1997 - 1999 Corvette: Service Bulletin: Accessory Drive Squeak (Replace Idler Pulley)

Subject: Technical - Accessory Drive Squeak (Replace Idler Pulley)

Number: 99-06-01-007

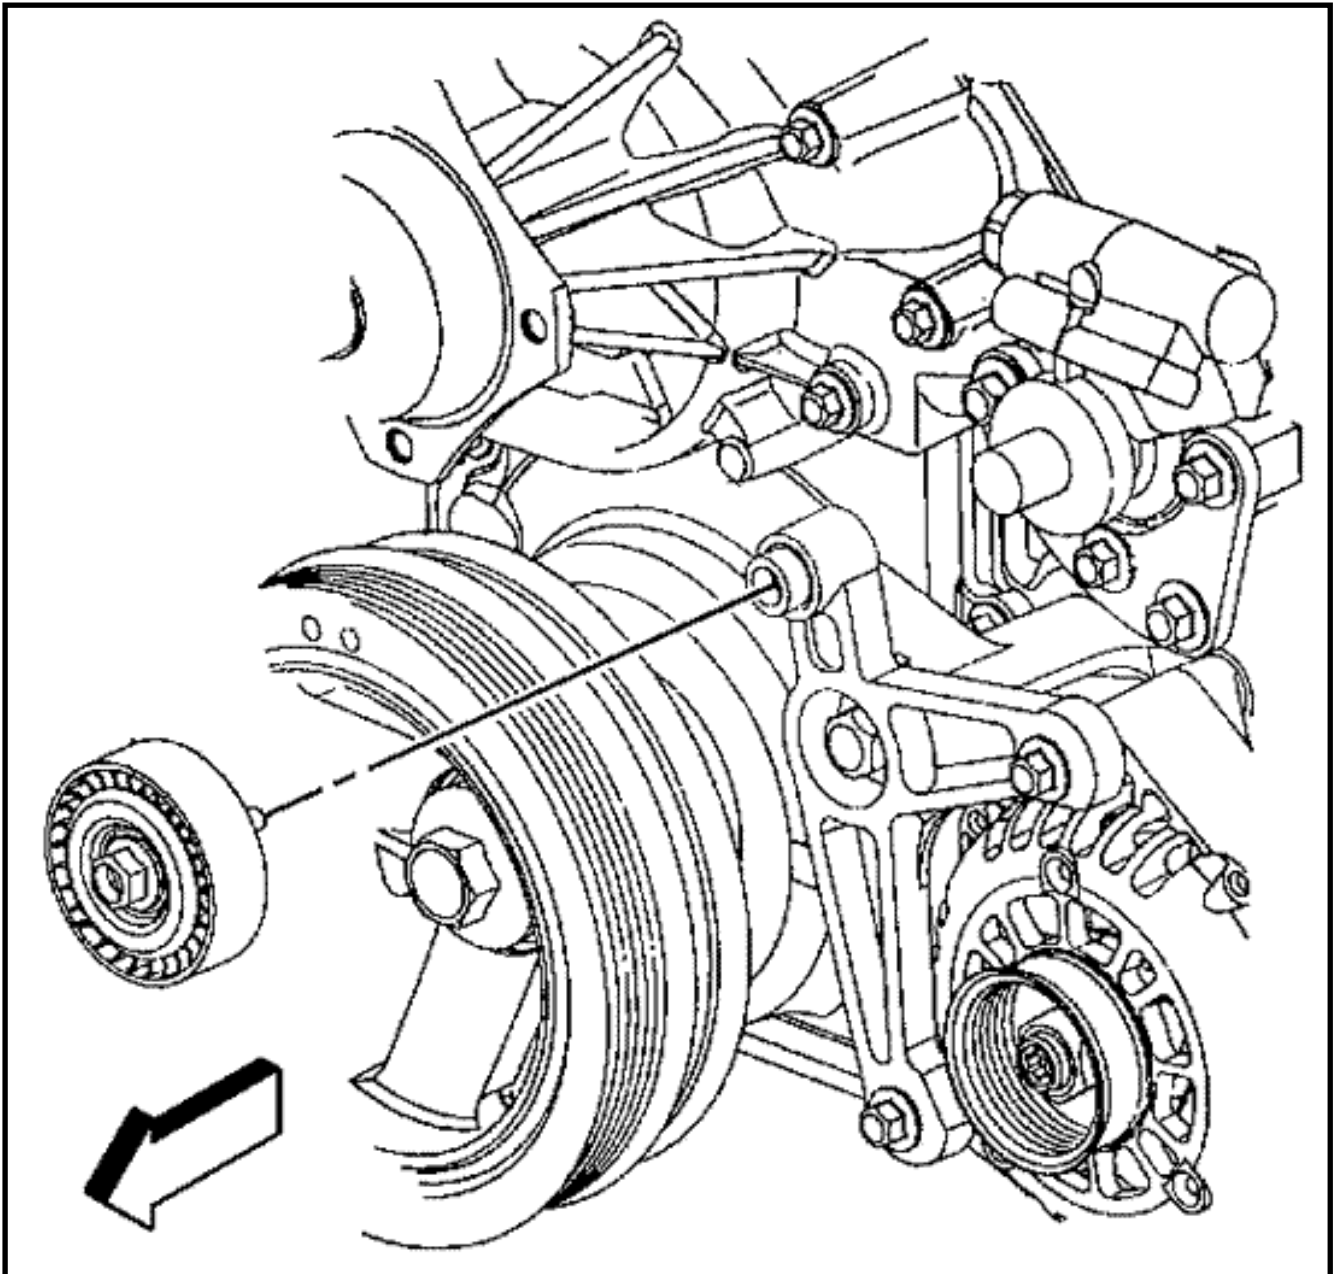
The idler pulley dust shield may distort during assembly due to torquing of the mounting bolt. This distortion may cause the idler pulley dust shield to contact the bearing race and the pulley resulting in the squeak noise.

A new idler pulley assembly is available with a thicker dust shield to prevent the distortion of the dust shield. The previous dust shield thickness is 0.61 mm. The new dust shield thickness is 1.37 mm.

- **Do not over-torque the mounting bolt or the condition may reoccur.**

Torque the idler pulley bolt to 50 N·m (37 lb ft).
